Job No: 2011-11-2633-ALTCOMM	Date Applied: 10/31/2011	CBL: 044- F-001-001	
Location of Construction: 68 HIGH ST	Owner Name: CHILDREN'S HOSPITAL HOUSING PARTNERS, LP	Owner Address: 309 CUMBERLAND AVE., SUITE 203 PORTLAND, ME 04101	Phone: 879-0347
Business Name:	Contractor Name: Wright- Ryan Construction	Contractor Address: 10 DANFORTH ST PORTLAND MAINE 04101	Phone: (207) 773-3625
Lessee/Buyer's Name:	Phone:	Permit Type: BLDG and CHANGE OF USE	Zone: R-7 Overlay
Past Use: University classes and offices	Proposed Use: To change the use of the existing building and to add a new building for a total of 38 residential dwelling units and parking	Cost of Work: \$6,251,000.00	CEO District:
		Fire Dept: <input checked="" type="checkbox"/> Approved - See conditions <input type="checkbox"/> Denied per original <input type="checkbox"/> N/A submission	Inspection: Use Group: R-2 Type: SB/2B IBC-2009 Signature: <i>[Signature]</i>

Proposed Project Description: Renovations 38 Unit Apartment Underground Parking		Pedestrian Activities District (P.A.D.) <i>1/27/12</i>	
Permit Taken By: Lannie	Zoning Approval

ELM TERRACE
68 HIGH STREET
PORTLAND, MAINE

Wright Ryan – Site & Building Shoring Extents Plan

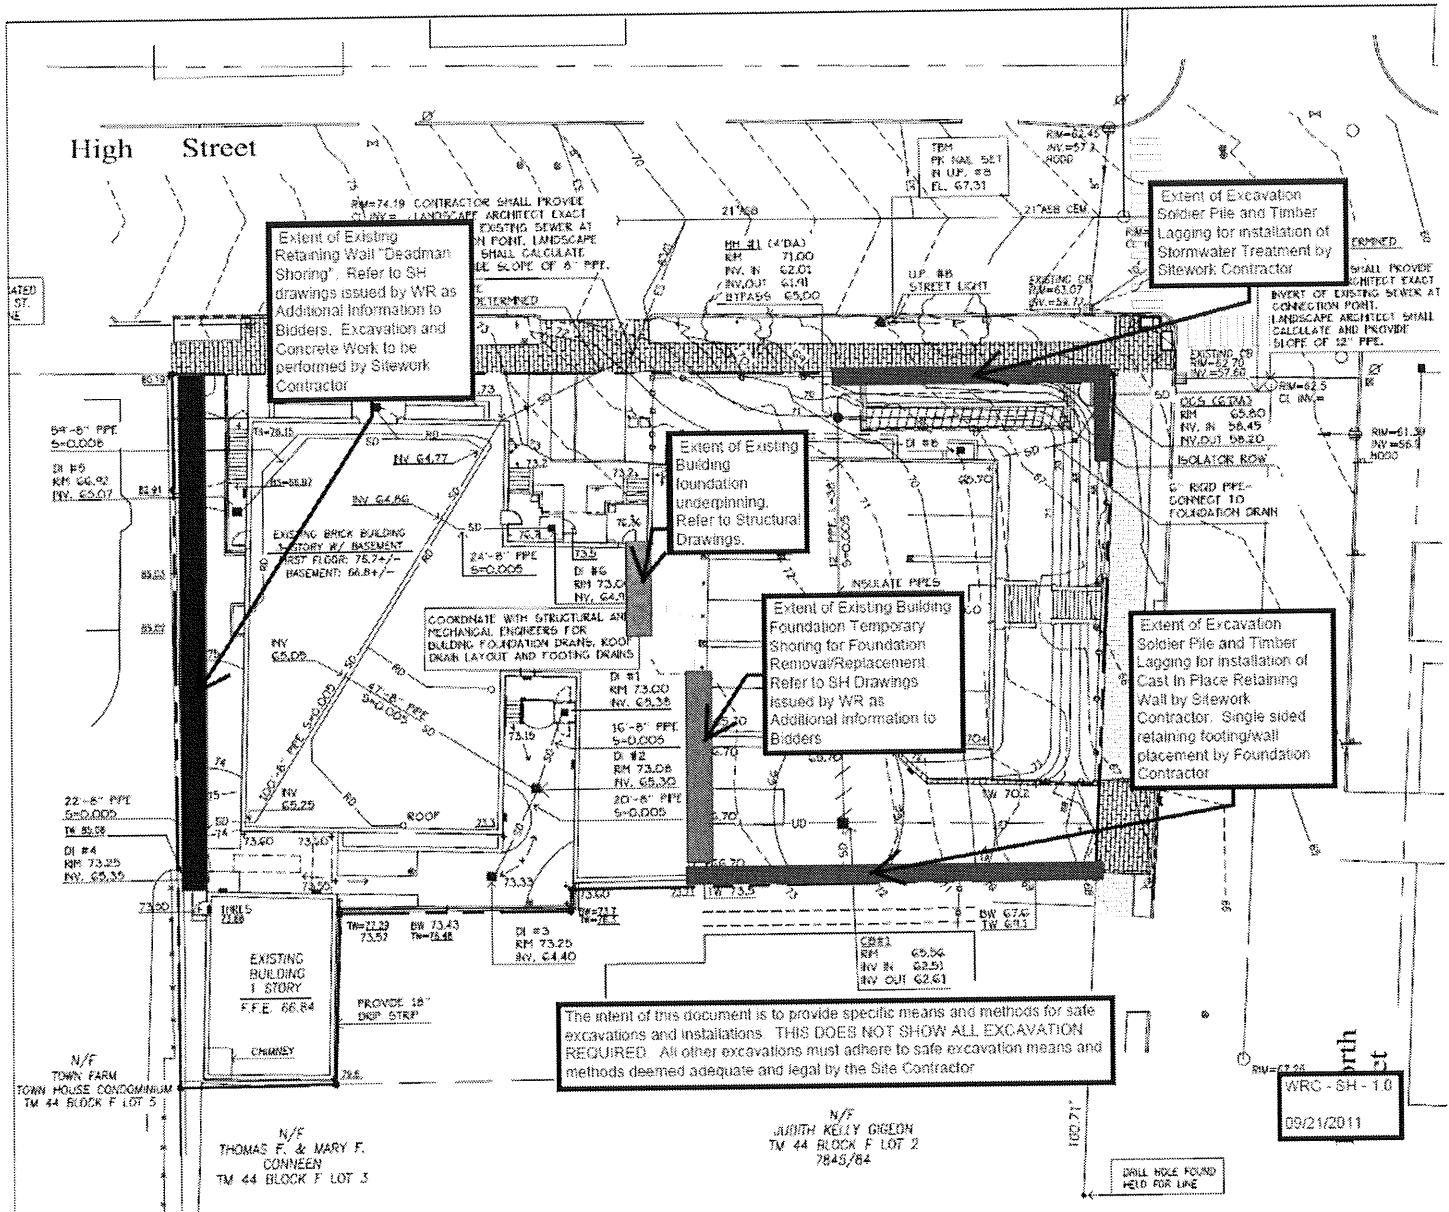
This document serves as additional instructions to potential subcontractors as it pertains to Site and Building Shoring.

- Shoring of existing building
 - Work is to be priced in accordance with documents included in Addendum 1 as additional information available to bidders
 - Substitute approaches will be entertained post bid
- Shoring of existing retaining wall
 - Work is to be priced in accordance with documents included in Addendum 1 as additional information available to bidders
 - Substitute approaches will be entertained post bid
- Excavation Shoring
 - Work is to be priced in accordance with documents included in Addendum 1 as additional information available to bidders
 - The design intent assumes the use of Soldier Pile with Timber Lagging
 - Vibratory Sheet Pile is not permissible.
 - Substitute approaches will be entertained post bid
- All other excavation support measures not indicated on the documents shall be the responsibility of the sitework contractor.

SKS-1-1

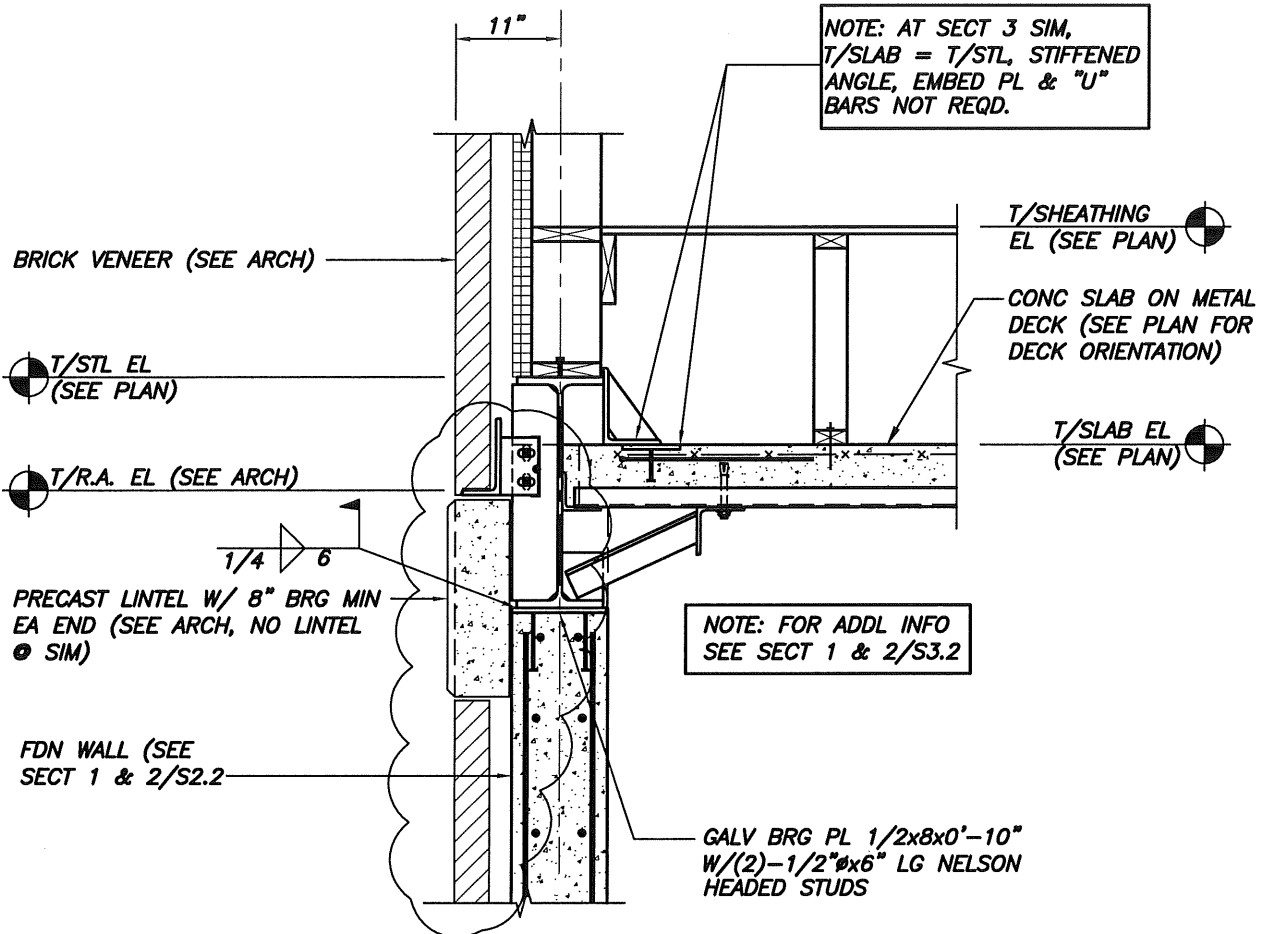
7. Replace detail 2 on Drawing S3.2 with the attached SKS-1-1.
8. Replace detail 3 on Drawing S3.2 with the attached SKS-1-2.
9. Provide square concrete column wraps (not round as indicated on Drawing S1.1) at all six (6) steel columns in the enclosed parking garage area [PARKING GARAGE - 001] per attached SKS-1-3.
10. At all continuous bearing floor trusses to be installed directly over the first floor concrete slab subfloor structure of the building addition wing, a) MSR lumber ratings are not required; and b) the bottom plate of the trusses shall be pressure treated.

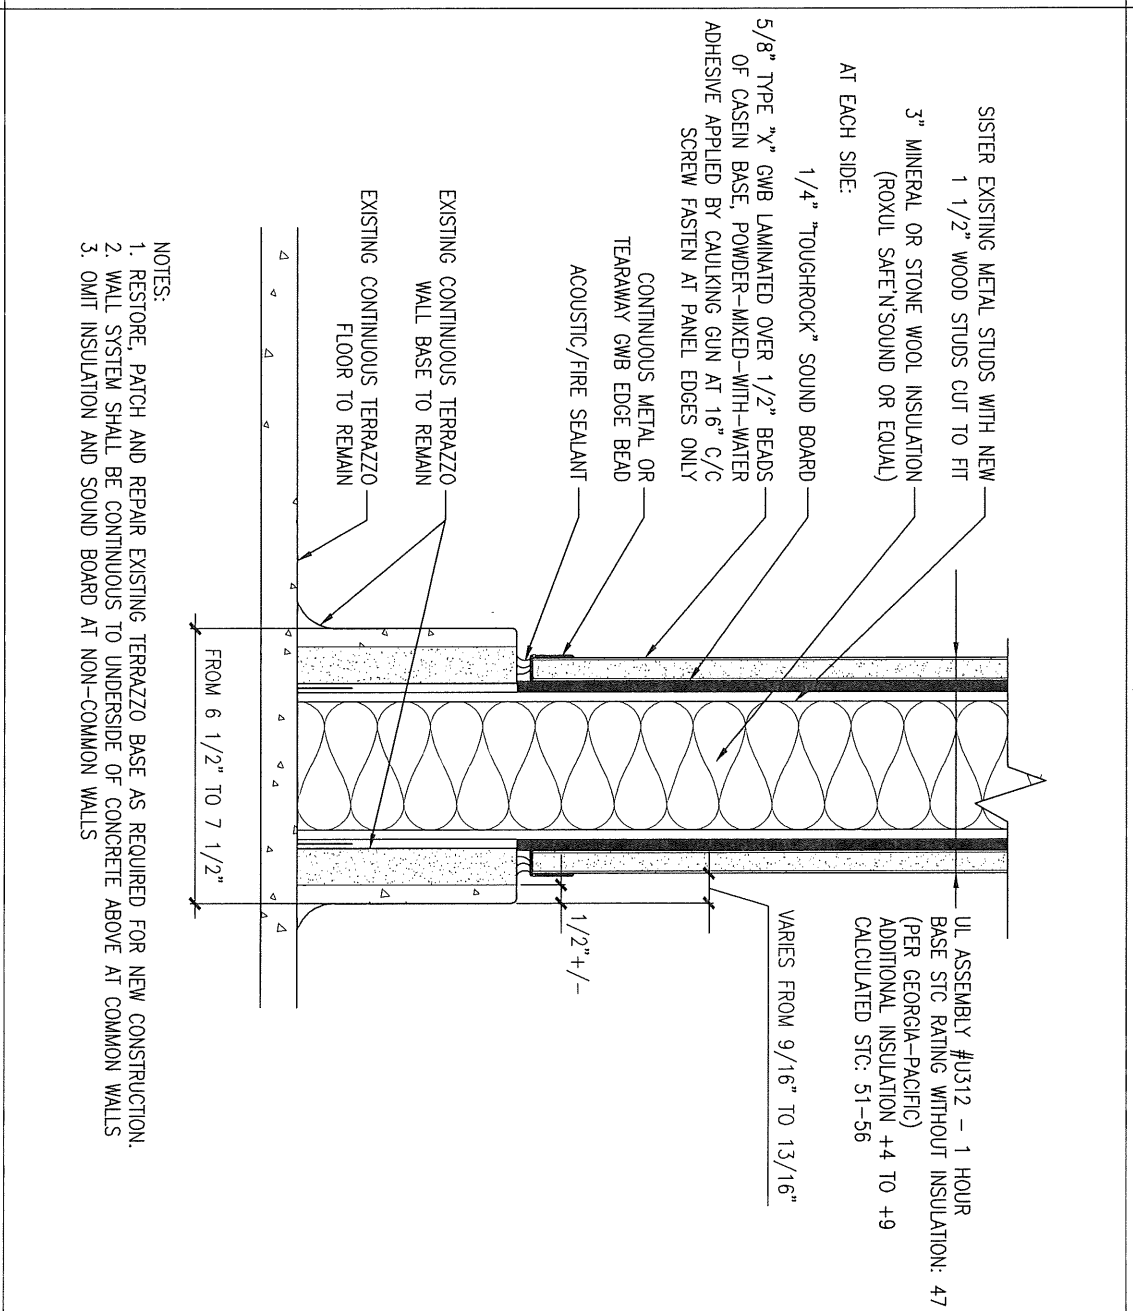
Jeanie: SKA-7 would replace Wall Types 17 (unit/unit common wall) and 18 (unit/corridor wall) that are shown on Drawing A0.02 Partition Schedule. They change 1 HR STC 50+ wall types to the same with different UL numbers and systems. Everything else remains the same. Is that all you need? Ben

Hi Ben,
Is this in the type 5B construction area?
Can you please provide the floor plans highlighting the specific walls to be changed with this new wall type.
